NUCLEAR PRODUCT ADVISORY:

BARTON 763/763A/764 Transmitter Heat Rise and Qualified Life

DOCUMENT NO.: 210316064.2

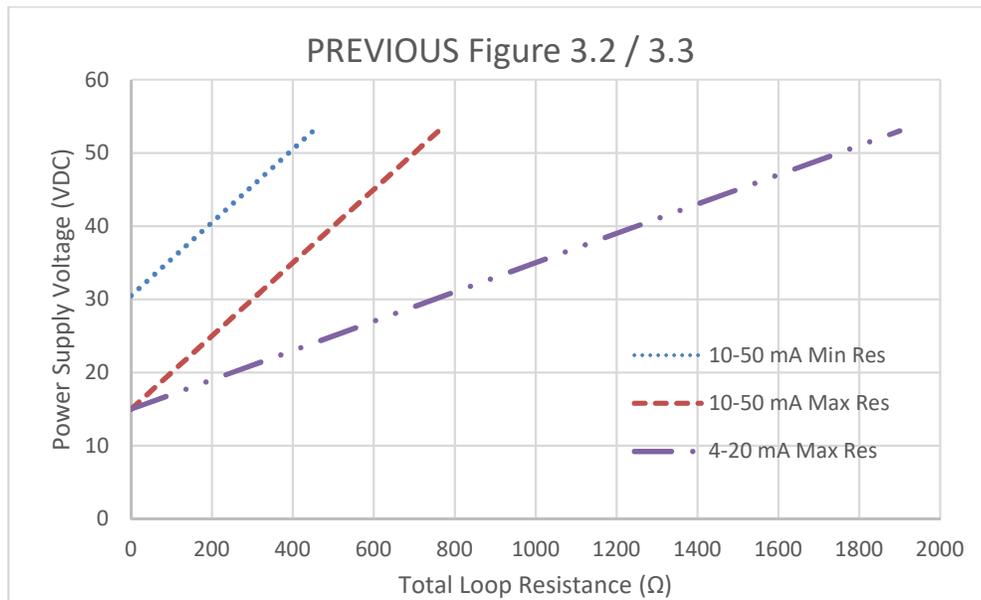
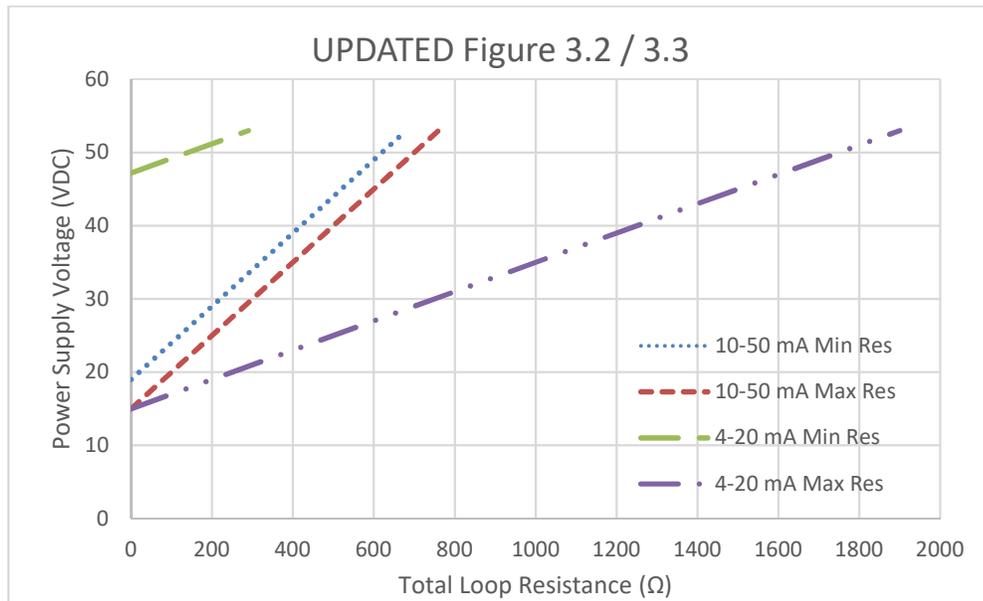
Cameron is in the process of updating the Model 763A and 764 user manuals, which will have updated Figure 3.2 and Figure 3.3 "Power supply v. Total Loop Resistance" figures incorporating heat rise considerations described here. The following two figures show the previous, and updated user manual figures.

NOTE: User manual updated power supply voltage v. total loop resistance Figure 3.2 / 3.3 is based on keeping life limiting component as the metal film resistor accounting for its heat rise. It is based on analysis for 50°C ambient temperature and transmitter operation at continuous full scale (100%) output. Lower ambient temperatures or lower continuous transmitter output would expand acceptable power supply and total loop resistance boundaries while maintaining or improving extrapolated qualified life.

Due to the potential for significant reductions in qualified life, Cameron recommends re-evaluating customer loop installations to ensure power supply and total line resistances comply with the updated figures as provided herein. Compliance with these updated figures will result in maintaining the original life limiting component (R1 metal film resistor), and only a slight reduction in qualified life from 40 years to ~35 years (at 50°C ambient) for all transmitters.

NOTE: The 9A-CR3-763-6 and 9A-CR3-764-9 reports' updated qualified life v. ambient temperature Figure 4-1.B is based on transmitter full scale (100%) output for the entirety of customer installation. Transmitter outputs below 100% will result in increase in qualified life.

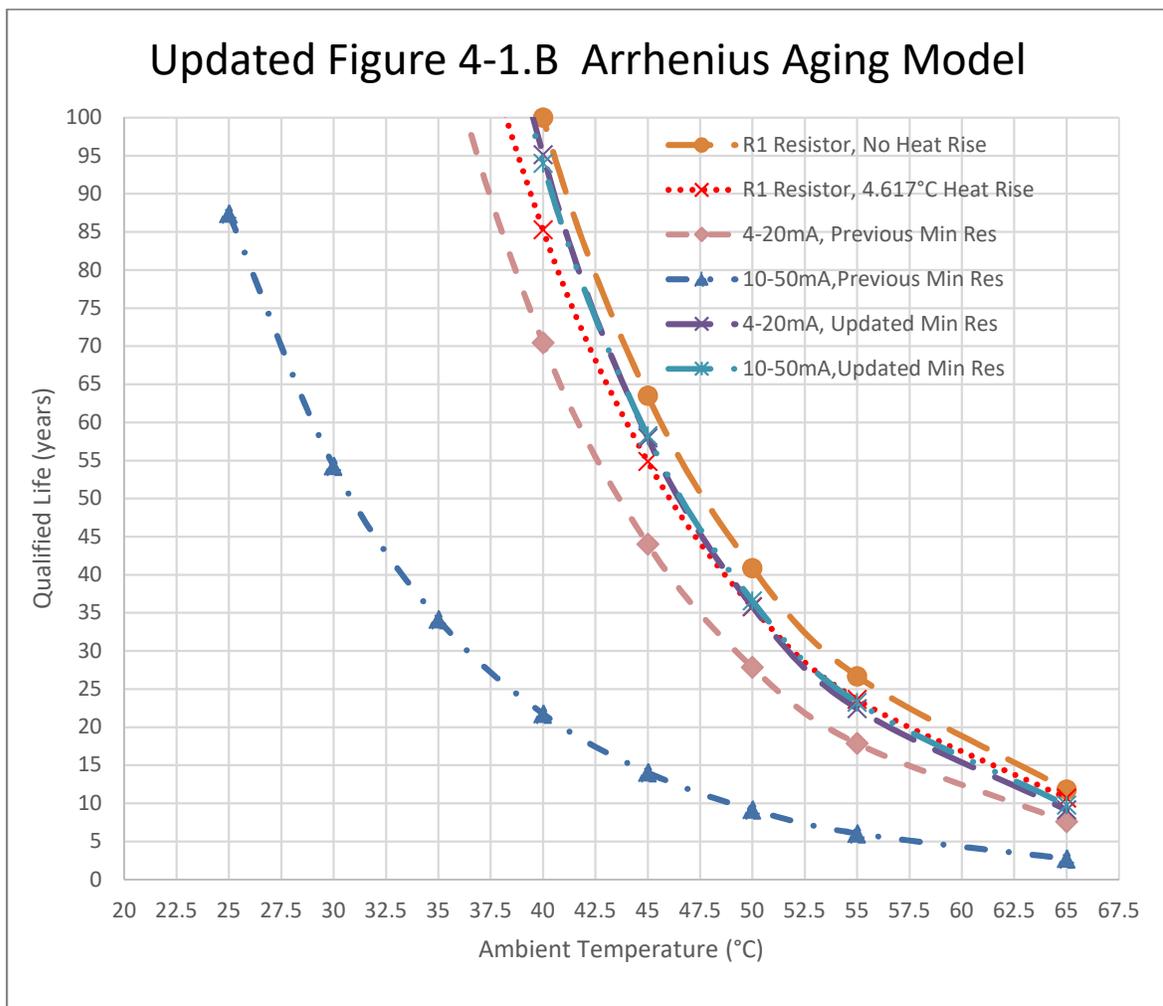
The Barton original report qualified life of 40 years at 50°C ambient temperature will no longer be valid when accounting for heat rise. It will instead be reduced to approximately 35.7 years at the same temperature, based on the heat rise in the R1 resistor. Furthermore, this reduced qualified life is only valid so long as the updated power supply voltage and total line resistance requirements are followed. Due to transistor heat rise considerations, use of the user manual's previously supplied power supply voltage and total line resistance lower limits could possibly result in significant reduction of qualified life if transmitters are continuously operated at full scale (100%) output. For example, for a 4-20 mA circuit operated continuously at 20 mA, qualified life at 50°C ambient could be reduced from 40 years, to 27.8 years. And for a 10-50 mA circuit operated continuously at 50 mA, qualified life at 50°C could be reduced from 40 years to 9.1 years.
